**RE: Highland Woods
East Greenwich, RI
Project #: 2406-001**

The purpose of this letter is to outline BMP A’s changes for the Highland Woods project per your comments #3 and #4 dated June 12, 2019. As we previously discussed via email, the ponds have been revised to have 3:1 slopes inside and 2:1 slopes outside with an 8’ wide berm while keeping 10’ away from the wetland edge or wetland buffer. To achieve sufficient volume, subdrains have been added to lower the groundwater table at detention pond A.

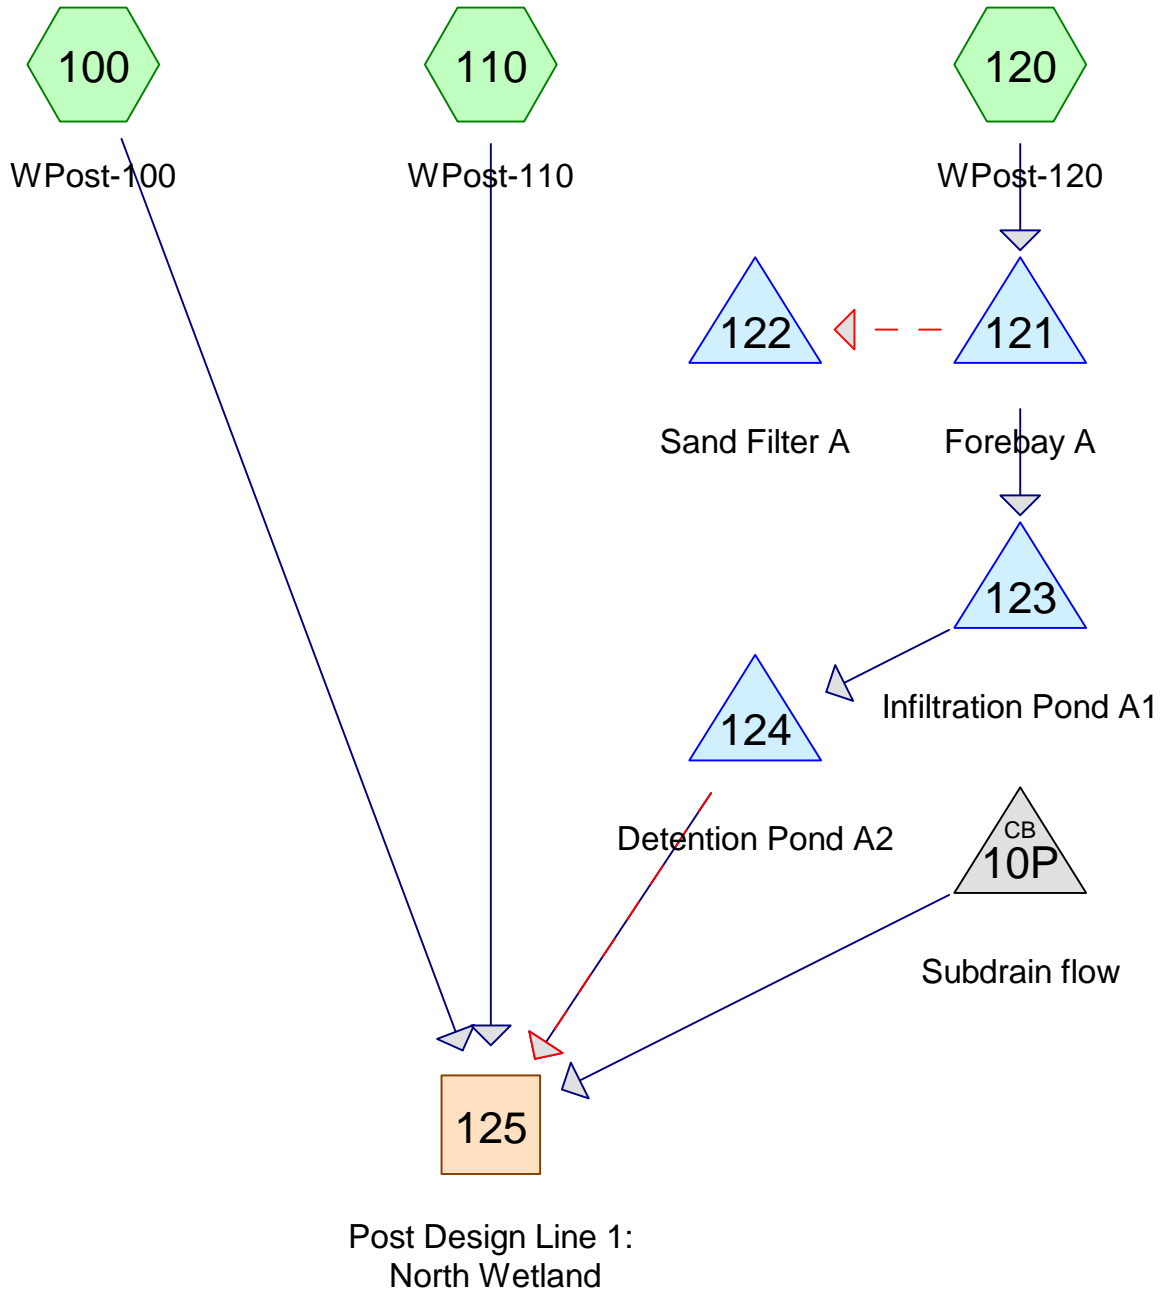
In summary, the revisions above address comments #3 and #4. BMP A has 3:1 maximum side slopes per comment #3. Comment #4 asks for 15' between the toe of the stormwater basin/pond embankments and woody vegetation and 10' has been provided per discussions via phone and email. The proposed subdrains, added to provide volume, will have no impact on the proposed BMPs, the wetlands, groundwater recharge or the Design Points.

The subdrains will intercept groundwater and ensure the bottom of the BMP is dry. The subdrains will then daylight at the closest possible location. While there is an infiltration pond adjacent to detention pond A, most subdrain influence is very limited, usually extending at most 25 feet.

The maximum potential flow from the groundwater (during the wet season) was determined using Darcy’s Law, $Q = kiA$,
Where Q is the flow (cfs), k is the hydraulic conductivity of the soil, i is the hydraulic gradient, and A is the area of influence. For this analysis, k has been assumed at a conservative 3.3 ft/day for sandy loamy soil and i is assumed to be 1 based on an assumed slope of 1:1 for the sandy loamy soil. A is assumed by the subdrain perimeter length (566 ft) and average depth of groundwater to be intercepted (1.5 ft) by the subdrain. Therefore,
 $Q = (3.3 \text{ ft/day}) * (1) * (566 \text{ ft} * 1.5 \text{ ft}) = 0.03 \text{ cfs}$

For these reasons, the subdrain base flow has been added to Design Point 1. HydroCAD printouts have been provided as an attachment. Even with the additional groundwater flows, there will be no or minor increases in runoff to Design Point 1 compared to the previous design flows. Any increases in flow are seasonal and insignificant. See table below for a comparison of existing flows, previous design flows, and revised design flows.

These calculations and analysis are based on the seasonal high groundwater table. This really only occurs two months out of the year. During the rest of the year we expect there will be little or no flow out of the subdrains.
